SEWAGE DISPOSAL TESTING

HOWARD COUNTY HEALTH DEPARTMENT
ENVIRONMENTAL HEALTH SERVICES

PROPERTY OWNER JAMES + LINDA BOGARD

SUBDIVISION DAISY RD LOT NO. 1

INDICATE NORTH - NAME ADJOINING ROADWAY AS BASE LINE.

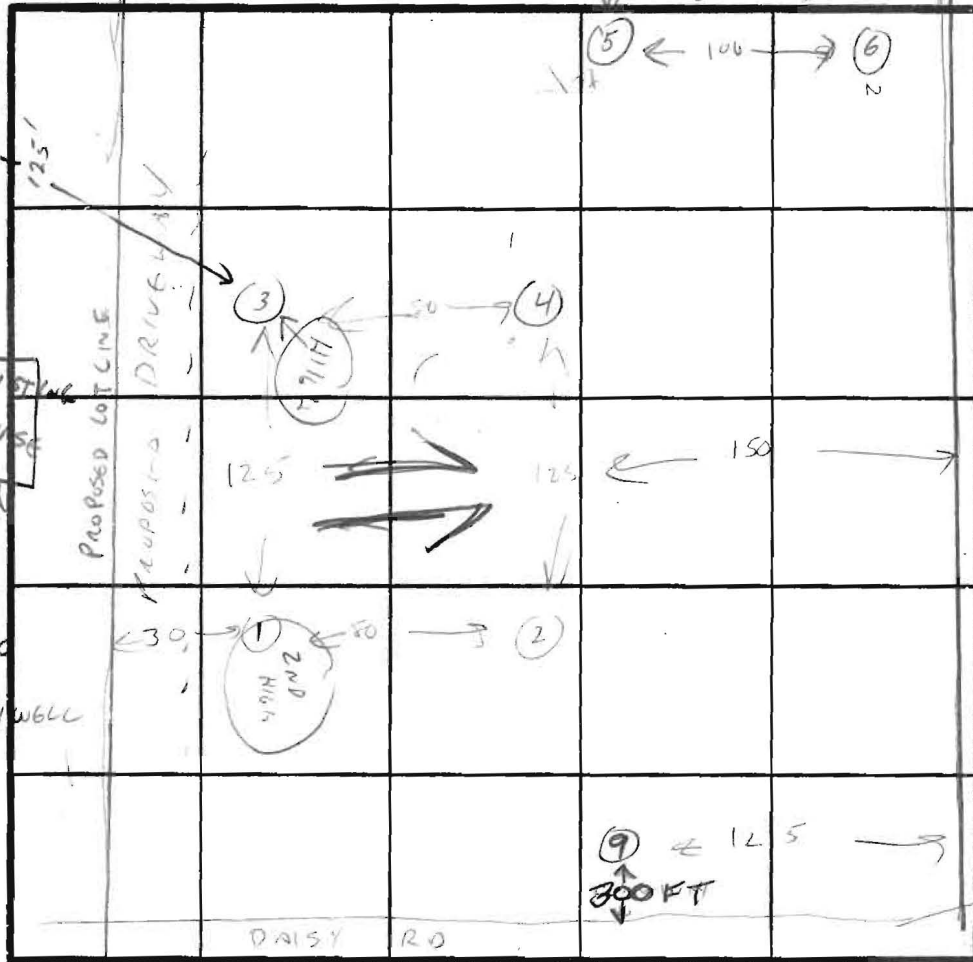
REASONS FOR REJECTION OR HOLDING OWNER NOTIFIED BY PHONE TO HAVE ENGINEER CONTACT THIS DEPT
TO DISCUSS SUBDIVISION PLANS. 5/8/85 CW

10,000 SQ FT ESTABLISHED BY PATTERN 1-2-3-4 BUT PDS NOT LEAVE SUFFICIENT REPAIR AREA FOR EXISTING LOT.

REMARKS ∴ HOLES 1-2-3 SHOULD BE INCLUDED IN REPAIR AREA FOR EXISTING LOT AND NEW ALTERNATE AREA 5-6-7-8 SHOULD BE USED FOR THIS LOT.
